SHEET TITLE:
Elevations
32'0" x 67'5" Custom Cape - Larry Daniels
#054107 (#R052104B) Plan#4 Davies

SHEET TITLE:
First Floor Plan
32'0" x 67'5" Custom Caps - Larry Daniels
FO54107 (#R052104B) Plan#4 Davies

SHEET TITLE:
Suggested Second Floor Plan
32'0" x 67'5" Custom Cape - Larry Daniels
#054107 (#R052104B) Plan#4 Davies

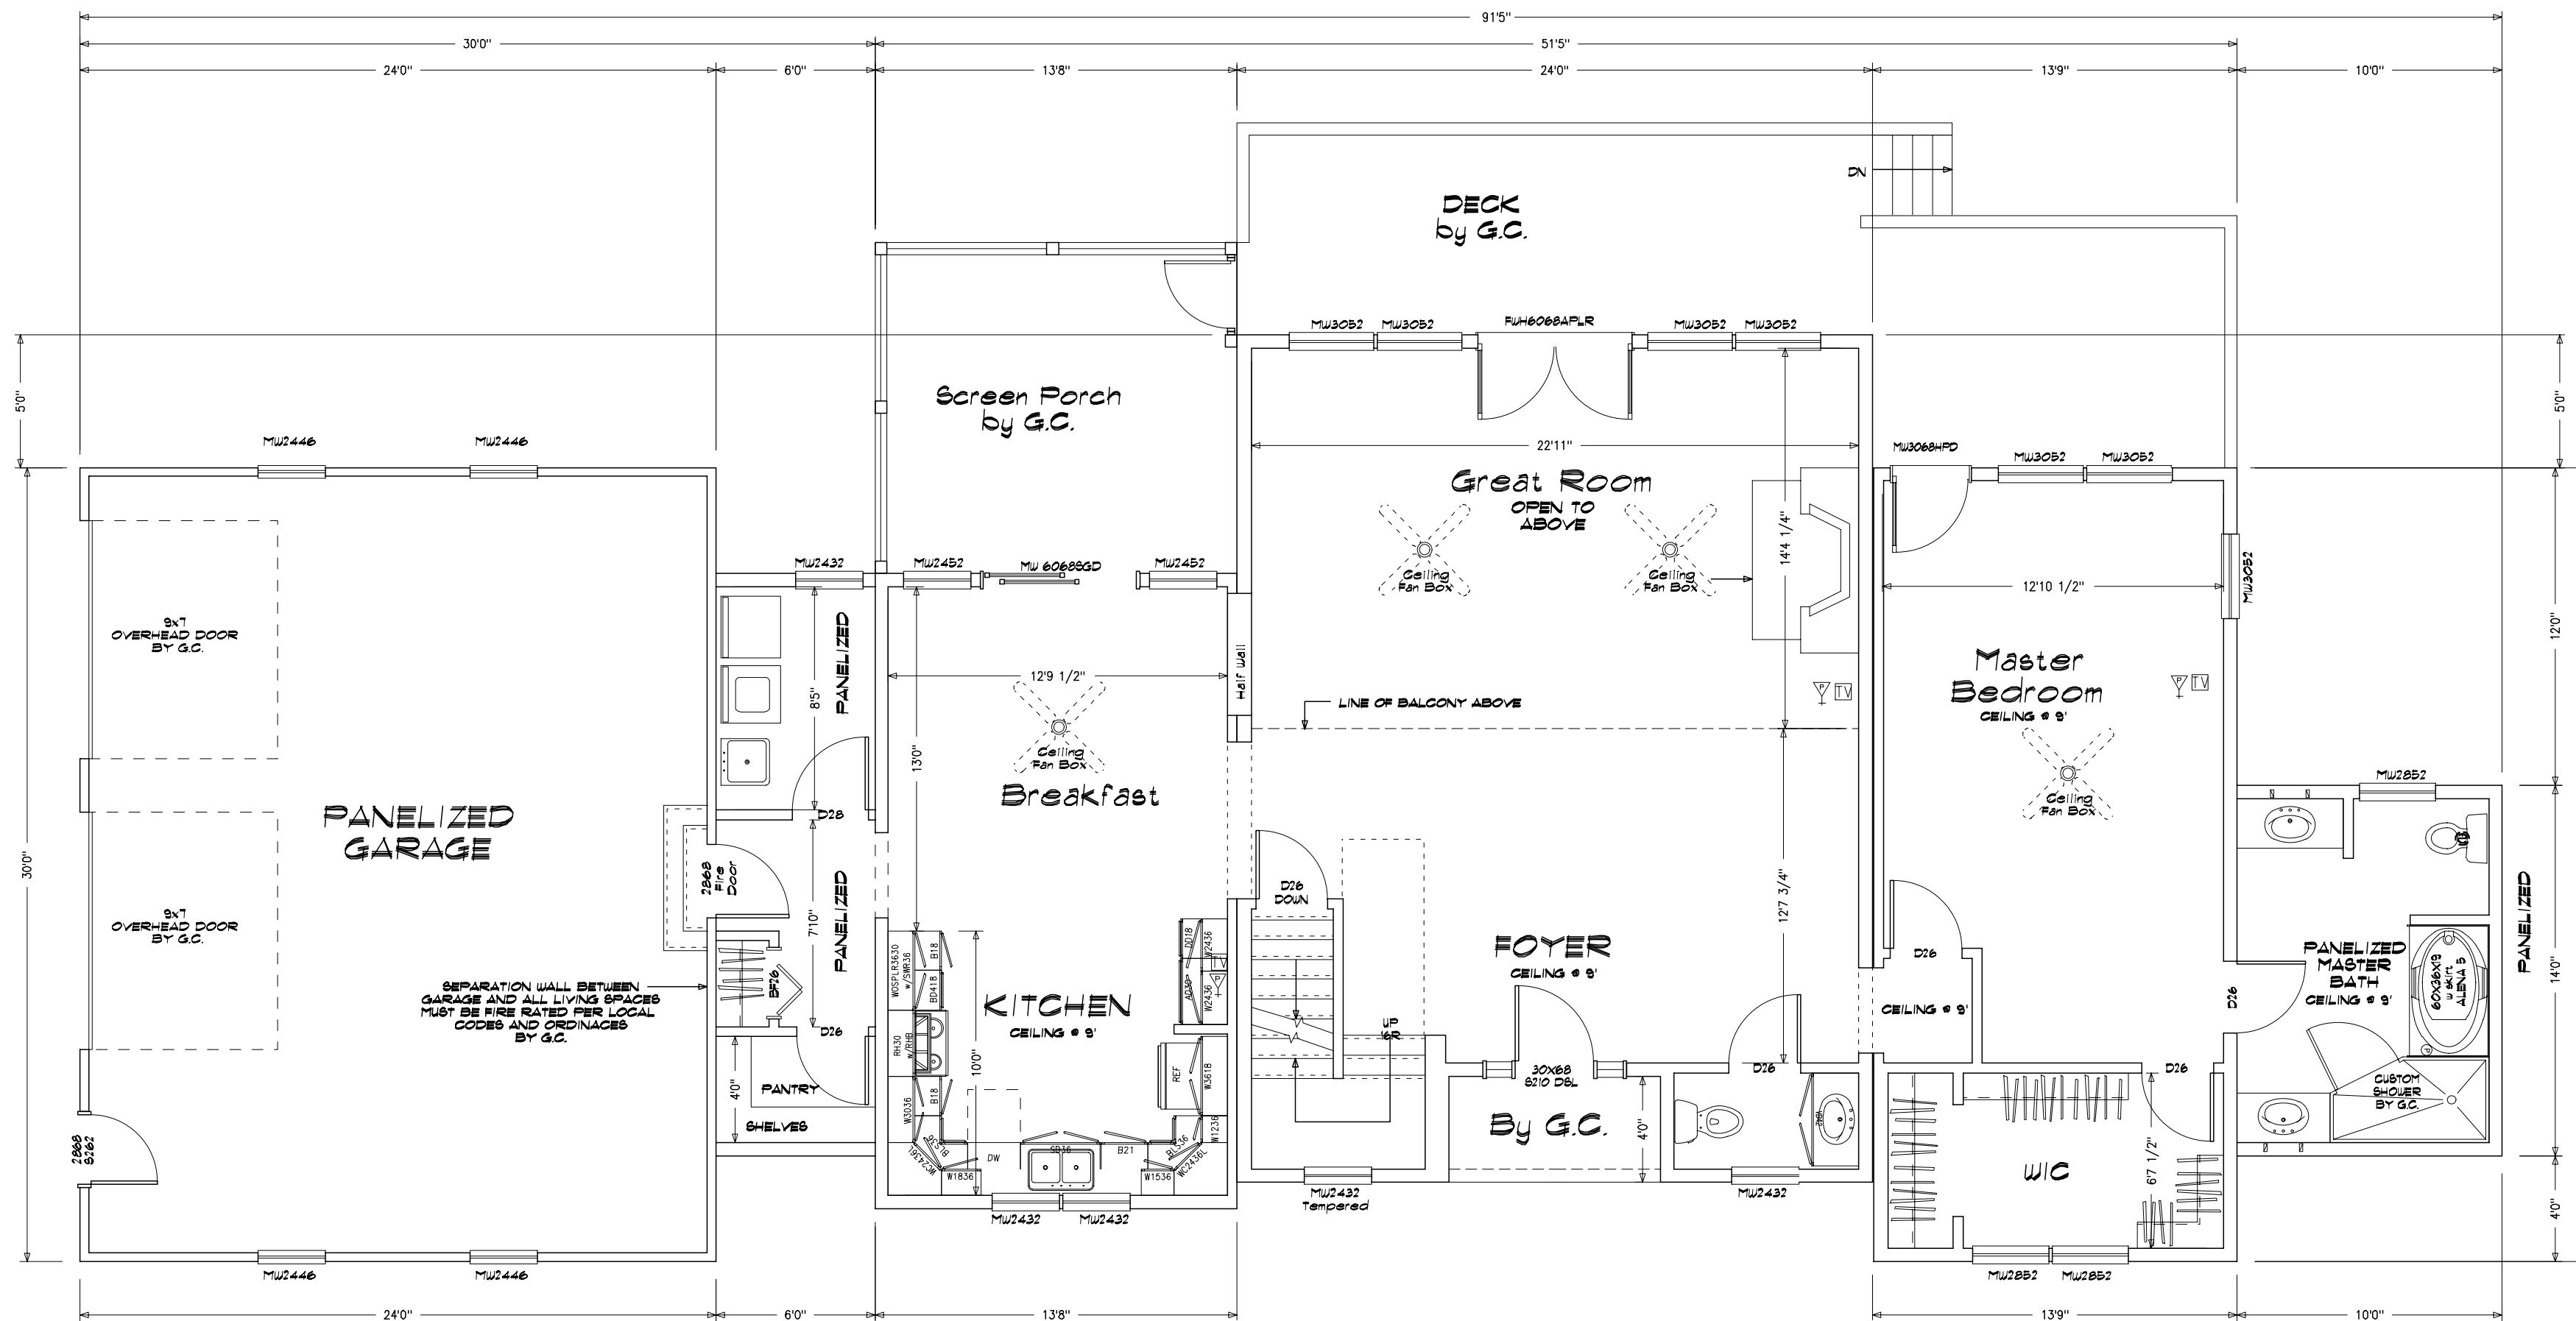
Plan #3 Changes

- Chg 2852 wins to 3052
- Show custom Glass, Grt Rm
- Desk in Kit
- Clf Fand Bedrms
- Show transom Win @ Garage Doors
- Delete door M.Bth
- Chg 2852 to 3046 Br #2
- Match Stair Win to 1/2 Bth Win
- Delete Bulkhead
